Meeting Agenda

Franklin Municipal Planning Commission

Thursday, October 22, 2015

C1.00

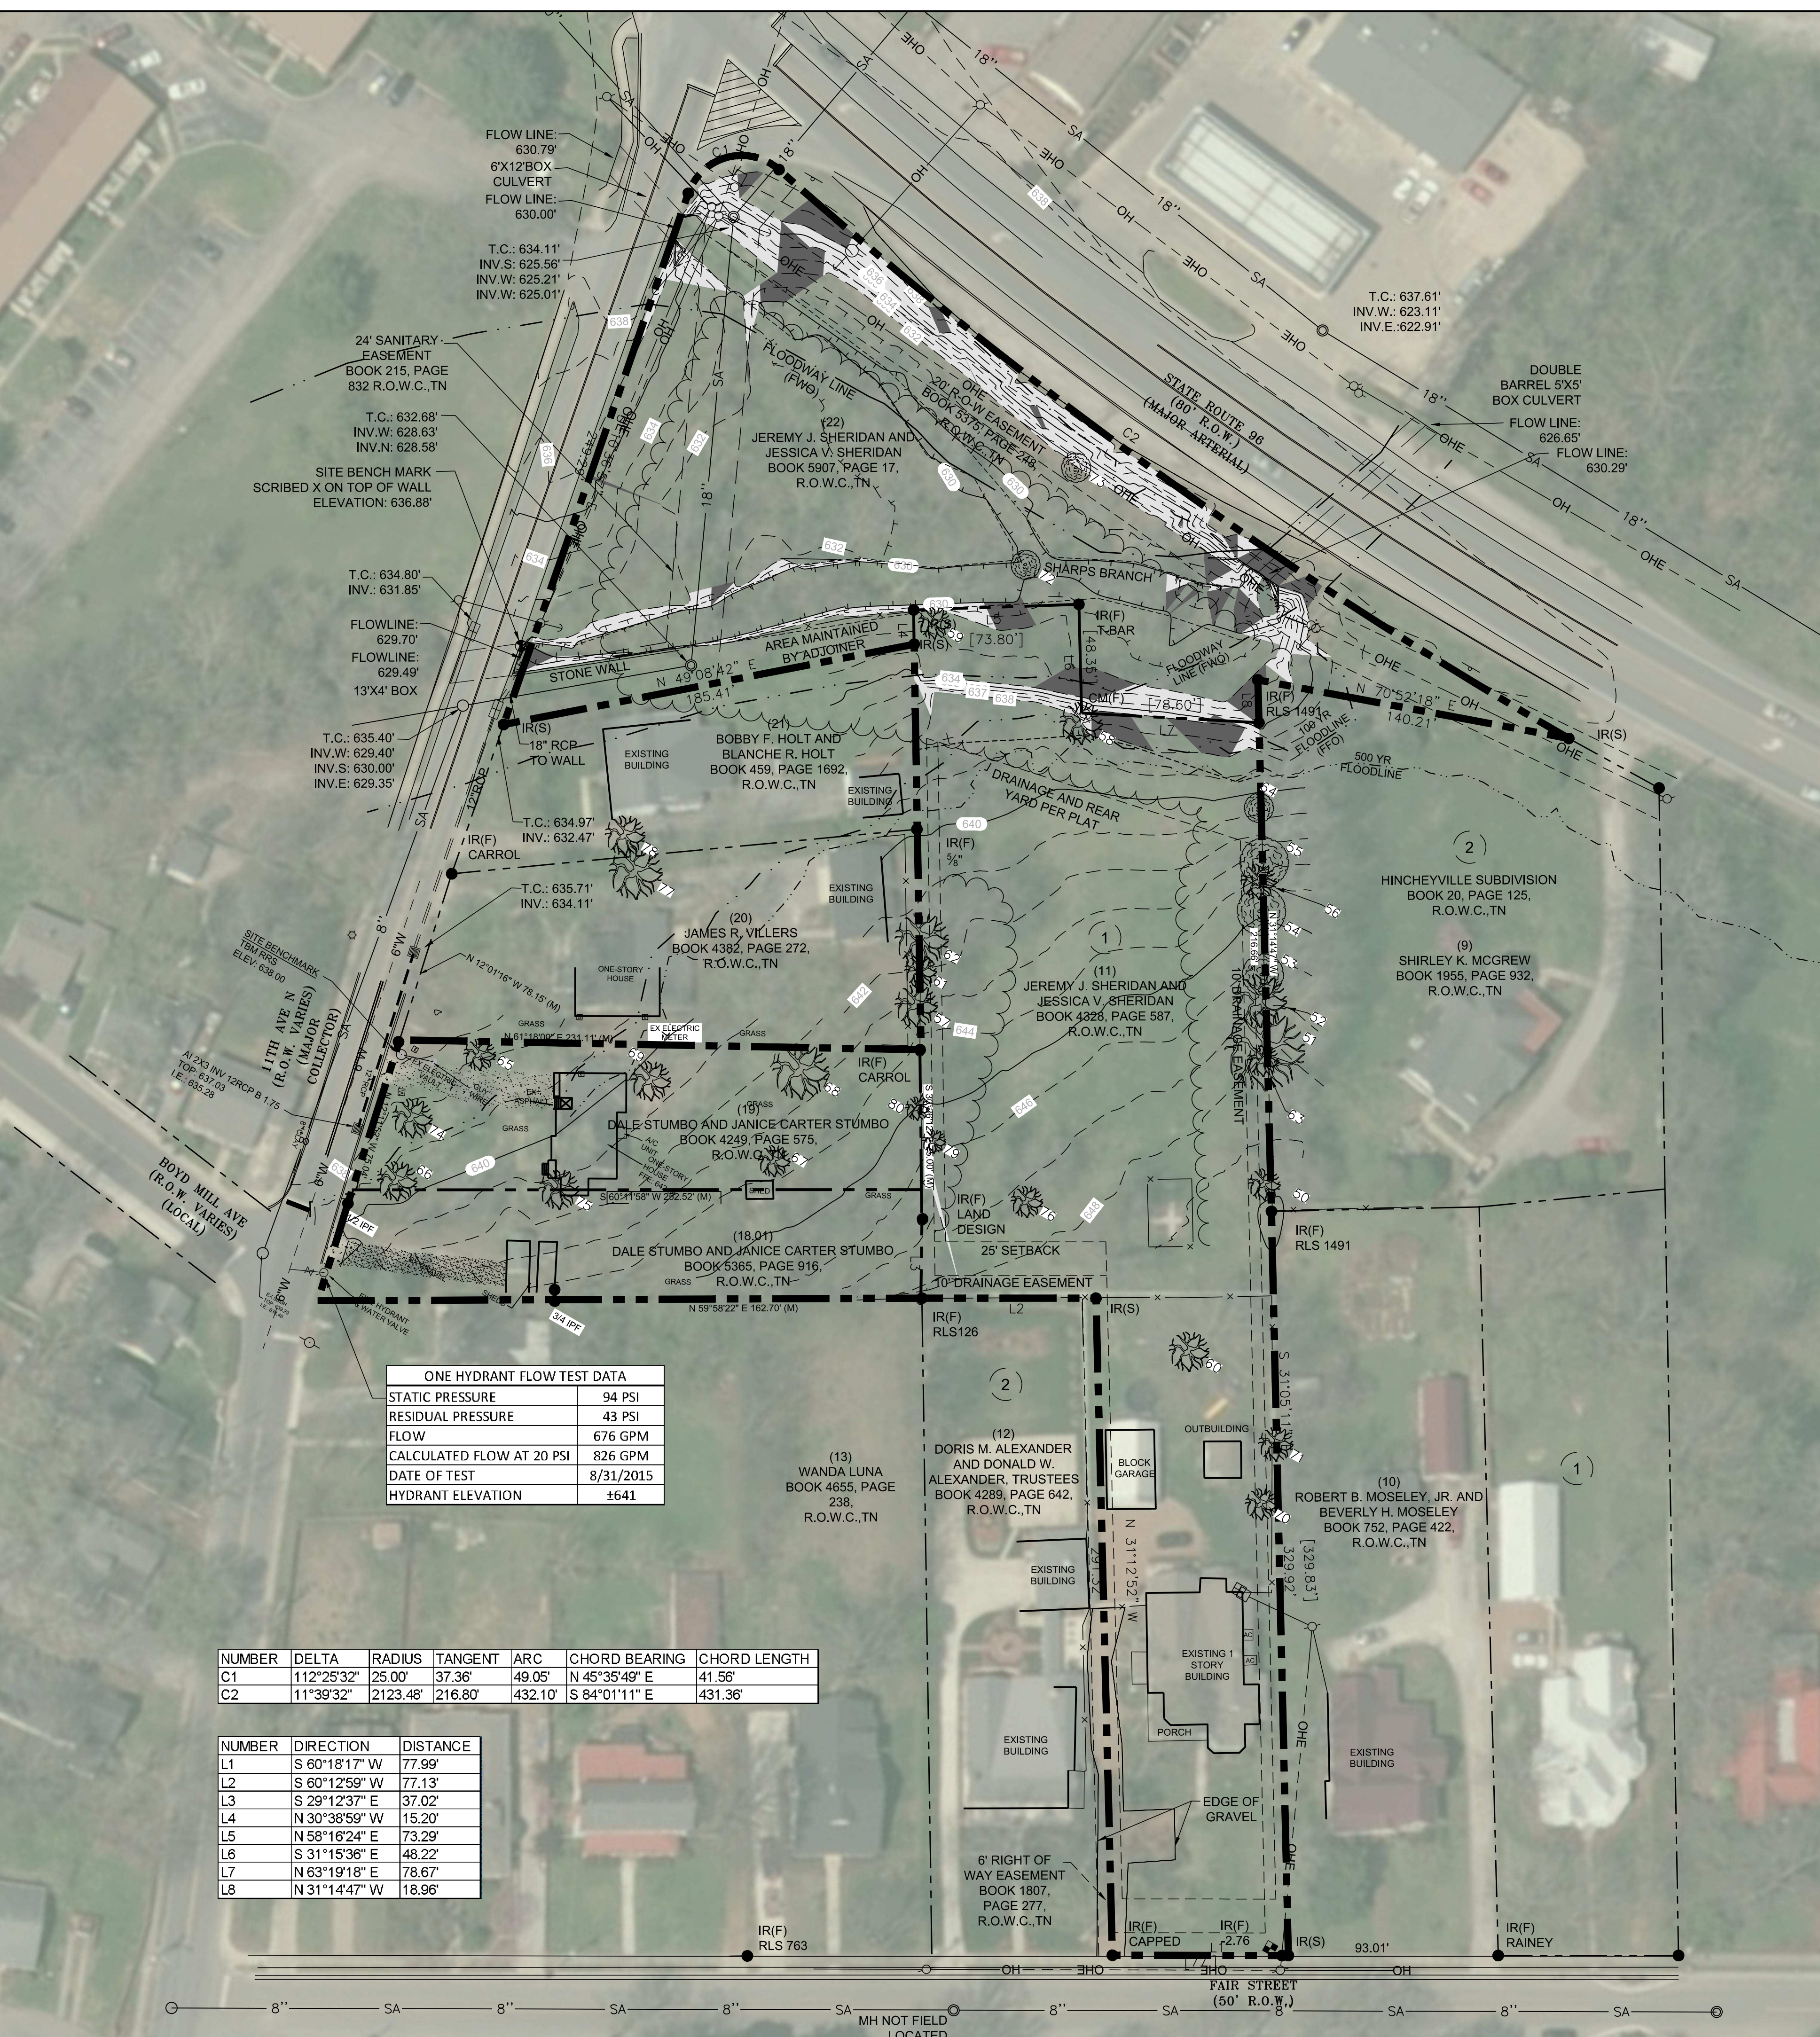
The applicant shall correct Note 21 on C3.00 which states Lots 2-7 shall have these systems and shall include Lot 8. Lot 1 is excluded as it is an existing dwelling.

C1.2

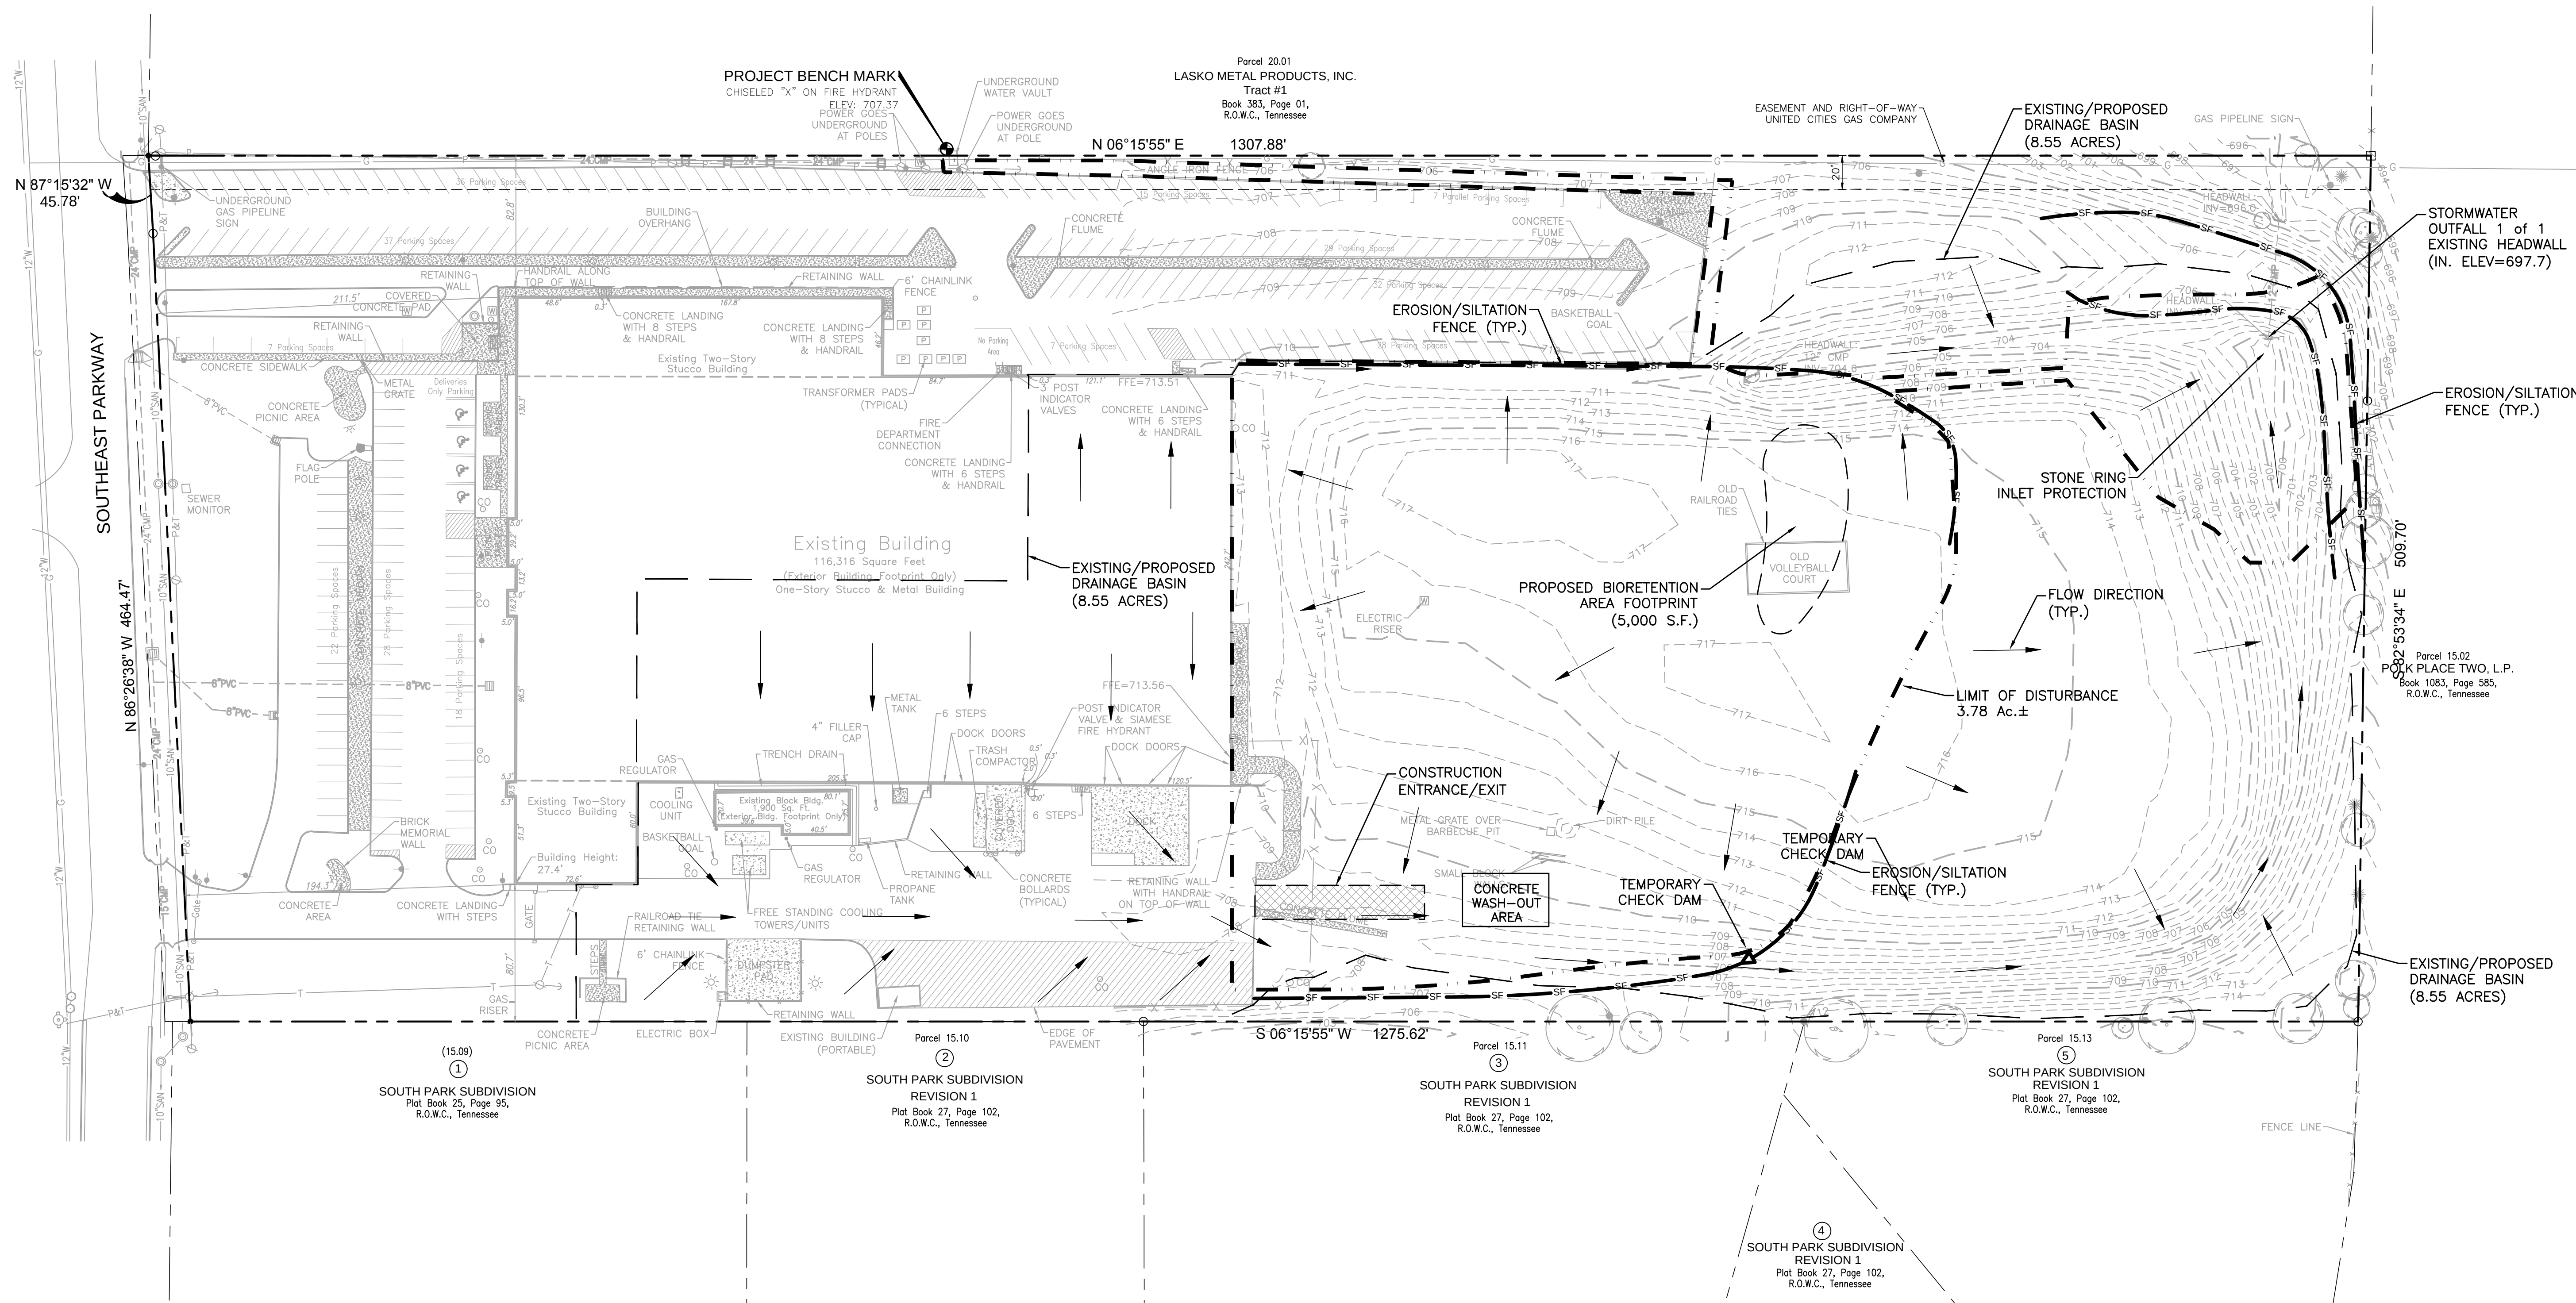
3. C1.1 - Enlarged Existing Conditions Plan

- Applicant shall delineate existing drainage basins and provide flow arrows, outfall locations with ID & Elevation. Where multiple drainage basins exists applicant shall provide Grading & Drainage Data Chart for each outfall location.
- Existing drainage basin characteristics have been called out on the new Sheet C2.0.
- Applicant did not address the comment: Applicant shall include Stormwater Narrative on Existing Conditions plan, recounting how stormwater is handled under existing conditions.
